Design Review Board Agenda

The Pointe Condominiums - Monument Sign

**CITY OF MILL CREEK
DESIGN REVIEW BOARD
APPLICATION PL2018-0016 - REVISED**

NAME OF PROJECT: The Pointe Residential Identification Sign

Attachment 2 - Proposed Sign Design

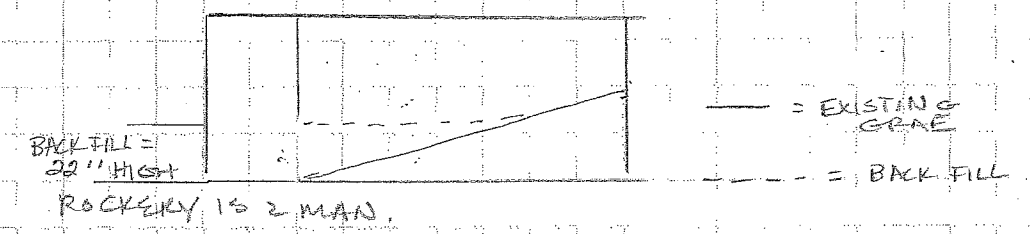
The Board discussed the proposal and had several questions regarding the fire hydrant, the utilities, and the actual height and area where soil will be added to level the site as well as the dimensions of the existing wall. Member Hastings suggested that the applicant contact the utilities for their requirements and to confirm that there is no conflict with the fire hydrant. Member Hastings felt that there isn't enough information to make a decision on the proposal tonight and suggested that a more detailed site plan be requested showing dimensions. The Board Members present agreed to a special meeting on August 15, 2018, so the applicant wouldn't be delayed too much in implementing their plan.

MOTION: Member Hastings moved to postpone a decision on the proposed monument sign because there wasn't enough information to determine if the sign is consistent with the design criteria contained in the Code. The applicant shall be asked to provide a site plan drawn to scale showing the area from the existing wall out to the sidewalk, showing all elements of the proposal including the existing wall, the landscaping, the one-man rocks, the proposed location of the new sign, the area where additional soil is proposed to level the site and including the street light, the fire hydrant, the utility boxes with exact dimensions. Also to provide the dimensions of the wall itself. The motion was seconded by Member Symms. The motion was approved unanimously.

WALLS
WALL POSTS ARE 4' x 4'
WALL THICKNESS IS SOLID
AND 10" THICK.
WALL IS 7 FT TALL

SOIL ADDED TO 22" DEPTH @ THE
DEEPEST ADDITIONS.
SEE OTHER SIDE

- A = WATER SERVICE (WILL BE WITHIN 2 FT OF PROP ROCKERY BUT NOT EXCEED 1 FT)
- B = PUD (WILL BE WITHIN 2 FT OF PROP ROCKERY BUT NOT EXCEED 1 FT)
- C = FIRE (WITHIN 8 FT BUT NOT EXCEED 6 FT)
- D = LIGHT POST
- E = SIGNAL
- F = SIGNAL
- G = PROPOSED SIGN PLACEMENT
